Application under Section 73 of the Town and Country Planning Act 1990

Application Ref. DC/26/0135

Resubmission of amended details for an application under Section 73 of the Town and Country Planning Act 1990 seeking to vary Planning Conditions 1, 5, 6, 11, 13 and 19 and remove reference to Planning Conditions 7 and 9 pursuant to the extant Reserved Matters Application Ref. DC/24/0249 at Rascals Farm, Shipley Road, Southwater, West Sussex

Plots 1 and 2 access

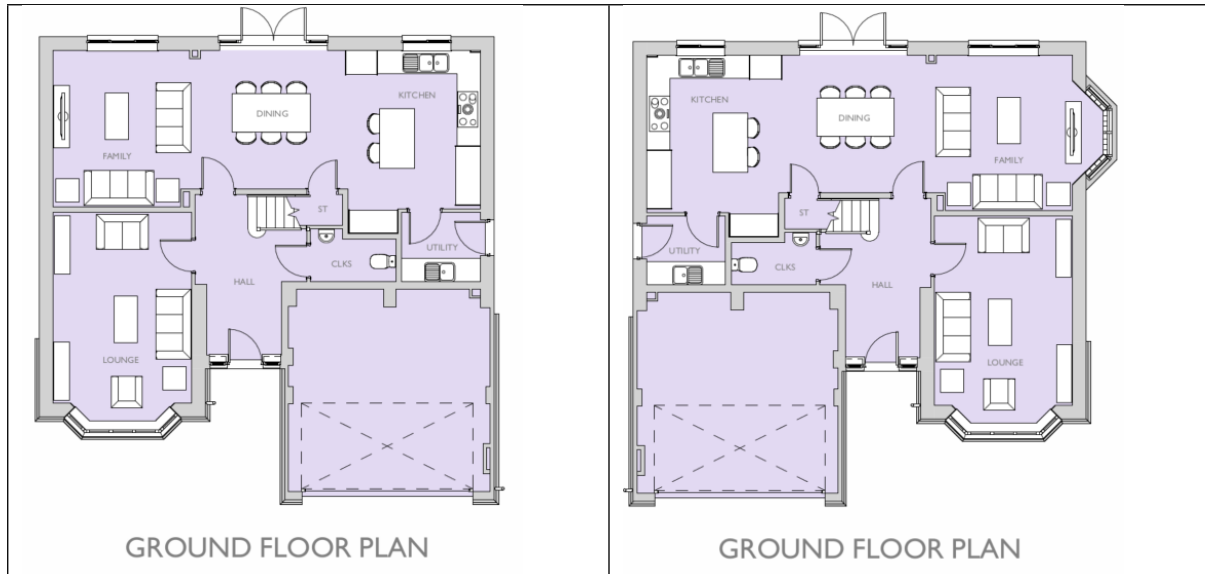
This access for plots 1 and 2 has been configured to not conflict with the RPA of the TPO Tree, English Oak (26)

Previous	Amended
----------	---------

Flat block elevations

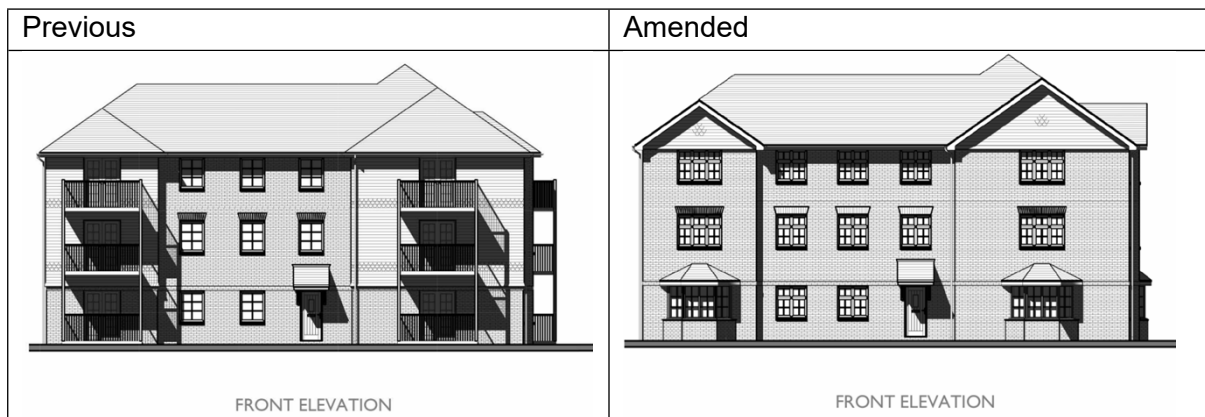
Following discussion with the Case Officer, the flat block elevations have been amended to closer align to that consented within the Reserved Matters scheme. Changes include:

- Removal of balconies
- Addition of Ground Floor bay windows
- Part-Gabbling of roof
- Addition of vertical tile hanging in roof gables with ornamental tiles
- Amendment of window style

Pathways outside of RPA

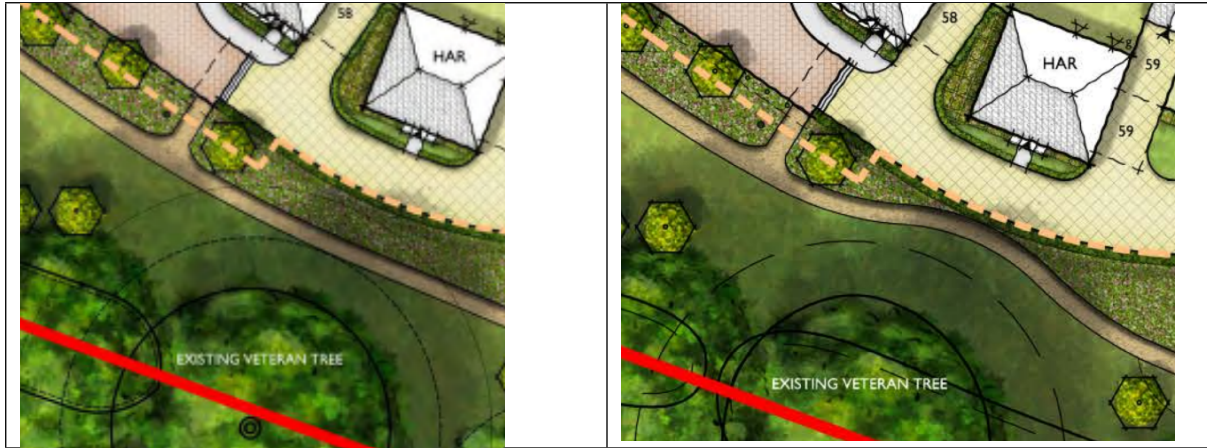
Following consultation from the Horsham DC Tree Officer, the footpath to the south of Plots 58 - 60 has been deviated to closer align to that consented within the Reserved Matters.

Previous	Amended
----------	---------
